PLANNING REPORT

Planning and Zoning Commission

Bright Road Reserve 24-135Z-PDP & 24-151PP

Address	4338 Bright Rd. & PID: 273-011149
Proposal	Rezoning 14.2-acre from R-1, Restricted Suburban Residential District to a Planned Unit Development District (PUD) and a Preliminary Plat for 20 single-family lots and associated site improvements.
Request	Review and recommendation of Rezoning/Preliminary Development Plan (PDP), and Preliminary Plat (PP).
Zoning	R-1 – Restricted Suburban Residential District
Planning Recommendation	<u>Recommendation to City Council of approval of a Rezoning and Preliminary Development Plan with Conditions</u> <u>Recommendation to City Council of approval of a Preliminary Plat with Conditions</u>
Next Steps	Upon review and a recommendation of approval of the Rezoning, PDP and PP by the Planning and Zoning Commission (PZC), the applicant will be eligible to move forward with the request to City Council.
Applicant	Bill Adams
Case Manager	Rati Singh, Assoc. AIA, Planner I (614) 410-4533 rsingh@dublin.oh.us

Site Plan

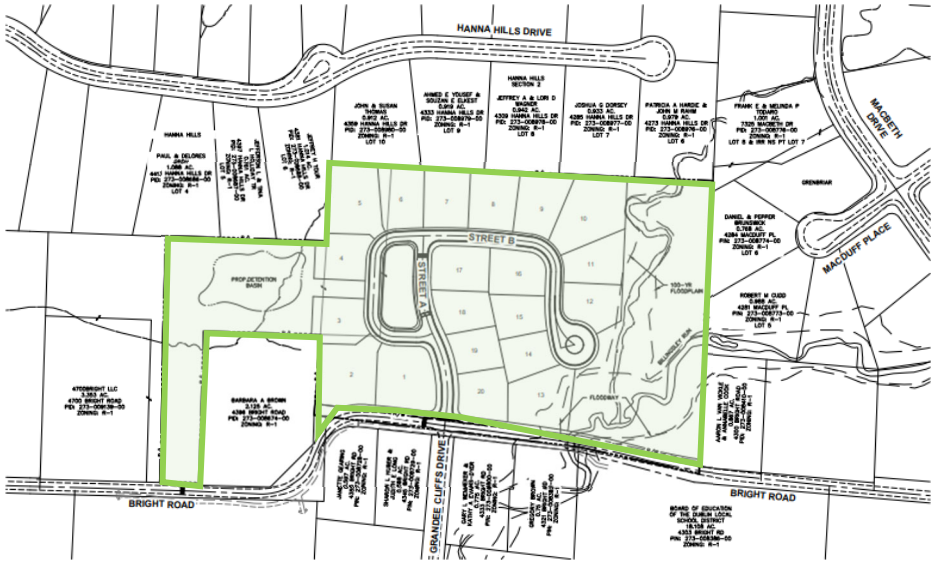
Staff has requested that the applicant provide factual details and implications of providing sidewalks on both side of the street and their impact on the proposed development. The applicant has provided a cross- section to show the required sidewalk on both sides and its

impact to the intended street character of the proposed development. However, no drawings are presented for staff to determine if the sidewalks would impact the development standards and the proposed layout and if they would deviate from the current layout and the intended theme of the proposal.

A diverse mix of naturalistically planted street trees is appropriate to the character of the site. The development text notes a 5-foot-wide tree lawn noted as standard throughout the development, but the drawings indicate 5.5-foot wide tree lawn, which tapers down to a narrower tree lawn, not adequate for a tree plantation. Code requires a minimum of 5-foot tree lawn, and Envision Dublin recommends an 8-foot tree lawn. The applicant must ensure that a uniform tree lawn is noted on the development plan and there are no discrepancies between the development text and the PDP drawings. Additionally, the landscape plan does not match the lot layout, and the submitted development drawings have discrepancies

It is important to note that there are discrepancies between the drawings and unresolved comments. Addressing these items may impact the overall site layout as presented. These items include the locations of sanitary sewer and storm sewer easements.

- 1) The applicant provide a 6-foot wide sidewalk on both sides of streets in the subdivision and revise the development text accordingly, prior to City Council submittal.

- 4) The applicant provide a uniform tree lawn within the entire development without any discrepancies between the drawings prior to City Council submittal.

Connections to City Networks

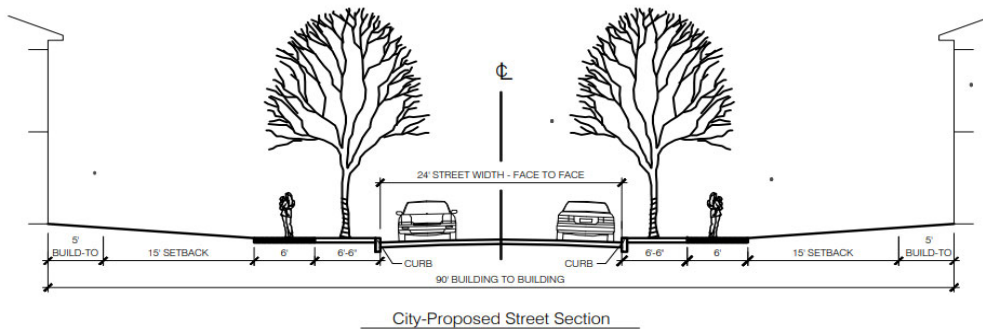
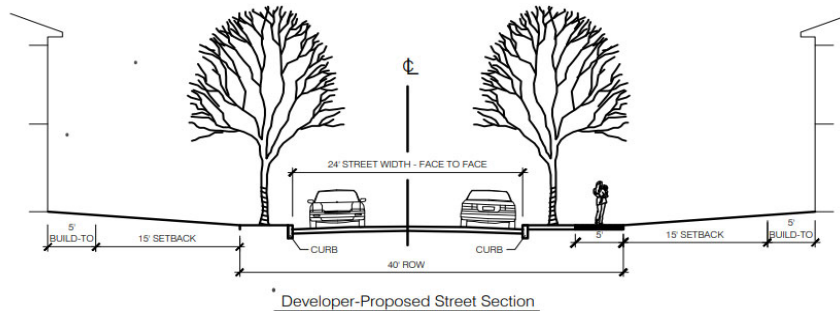
The proposed development is an infill project surrounded by single-family residential neighborhoods and is accessed only via Bright Road, which is a cul-de-sac. No additional road connections are planned for this development. A small portion of the site borders Bright Road across Ferris-Wright Park. To facilitate maintenance of the detention basin, a 10-foot wide shared use path will be provided as an access corridor from Bright Road. A crosswalk is provided at the south terminus of the shared use path, connecting the development to the existing Ferris Wright Park preservation area. The developer is also proposing an 8-foot wide specialty pavement path, approximately 140 feet long, to be constructed from Central Court to the east side of the detention basin, giving residents access to the West Wood and community open space. Staff recommends a continuous shared-use path from Bright Road to the neighborhood, ensuring pedestrian and ADA connectivity throughout the proposed development from the southwestern portion of the site. The shared use paths are recommended to be constructed per the City’s standards. If the applicant intends a specialty path to align with the development character, the maintenance responsibilities of the path should be described in the development plan.

- 2) The applicant provide a connected shared use path in Reserve A, per the City’s maintenance standards and revise the development text as required, prior to City Council submittal.

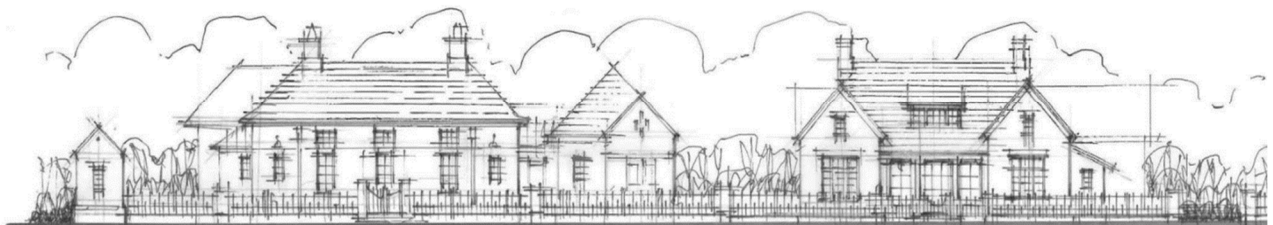
The lot sizes are typically larger along Bright Road and along the northern parcel line, to align with the adjacent lot sizes. The mix of lot sizes aligns with the Community Plan recommendations, however the minimum lot size does not align with the minimum lot requirements of 0.5-acre. Given the sensitive approach to preserve the existing natural features, staff is supportive of the proposed lot sizes which vary from 0.22-acre to 0.49-acre. Lot sizes and setbacks vary throughout the development with varying lot widths. Lots 2, 5, 10, and 13 are the inside corner lots with narrow widths varying from 29 feet at Lot 5 to 43.1 feet at Lot 10. Staff recommends that a minimum of 40-foot lot width be maintained at all the inside corner lots to ensure flexibility in the driveway and front yard landscaping opportunities, which is an essential component of the neighborhood.

The lots sizes and locations dictate the side and rear yard setbacks. The minimum side yard setback is 6 feet. The NDG recommend that in no case shall the side yards be less than 6 feet on one side and 14 feet total. The Development Text proposes a range of dimensional requirements for rear yards and private open space areas which are unique to lots based on the lot configuration. For lots 1-10, based on the information provided, the minimum depth of private open spaces is not accurate and there are a number of inconsistencies in the numeric standards proposed for several of the lots for these elements, such that the numbers do not add up correctly. This information was requested multiple times, but not properly addressed by the applicant. Revisions will be required to the Development Text to ensure that adequate depth is available for both the buildable area of the house and private open space while maintaining a minimum rear yard buffer to the adjacent lot.

To ensure that the objectives of the NDG are met, minimum setbacks should be included in the Development Text for front and side loaded garages relative to the front façade of the home.

- 3) The applicant make adjustments to Lot 2, Lot 5 and Lot 13 to provide a minimum lot width of 40 feet to achieve more flexibility in driveway location and provide landscaping opportunities for a cohesive residential appearance and revise the development text to require the minimum lot width of 40 feet, prior to City Council submittal.

- 6) The applicant revise the development text to require minimum side yard dimension as 6 feet on one side and 14 feet total prior to City Council submittal.

- 7) The applicant revise the development text to provide minimum setbacks for the front-loaded and side-loaded garages, prior to City Council submittal.
